PRODUCT PROFILE

X006562 12" Quick Release Dust Cup with Dust Dumpa

Product Profile No. 10PP001 (09/10)

Cone Cup with Dust Dumpa

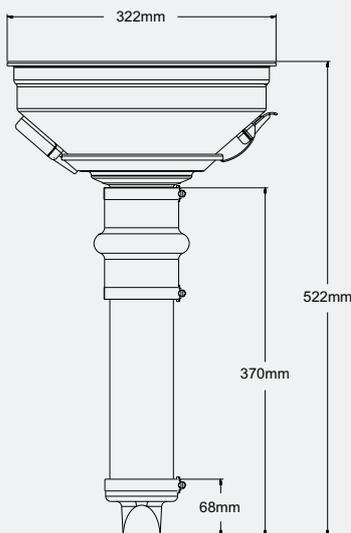
The X006562 12" Quick Release Dust Cup with Dust Dumpa has been released as a replacement for the P902340 Cone Cup with Dust Dumpa.

The benefits of using the X006562 12" Quick Release Dust Cup with Dust Dumpa in place of the P902340 Cone Cup with Dust Dumpa are:

- ☑ The X006562 uses a quick release vacuator style dust cup that has a latched trapdoor rather than a fixed cone shaped cup;
- ☑ Monitoring the condition of the Donaclone (cyclone) precleaner tubes as well as contaminant build up in the bottom of the lower body is now a simple latch away;

- ☑ There is no longer any need to completely remove the dust cup to inspect the tubes, one latch and you're done;
- ☑ Maintenance costs are greatly reduced and machine uptime is increased as removing and reinstalling dust cups is very time consuming, plus there is always the danger that the o-ring that fits between the top of the dust cup and the bottom of the lower body of the air cleaner could be dislodged, or even fall off during this operation, resulting in loss of precleaner efficiency;

- ☑ The X006562 is also fitted as standard with the P618619 upgrade trapdoor gasket that ensures the seal between the trapdoor and cup is airtight. Any leak in this area will greatly reduce the efficiency of the precleaner tubes (refer Product Profile 10PB001 for more details);

- ☑ Dust Dumpa ensures that the dirt separated by the precleaner tubes is quickly expelled via the vacuator valve, which not only keeps the precleaner tubes clean and operating at peak efficiency, but also helps to prevent dirt build up in the bottom of the lower body. The clear tube makes monitoring the bottom end of the air cleaner much simpler, saving maintenance costs and increasing machine uptime (for more details about the Dust Dumpa, refer Product Profile 10PB001).
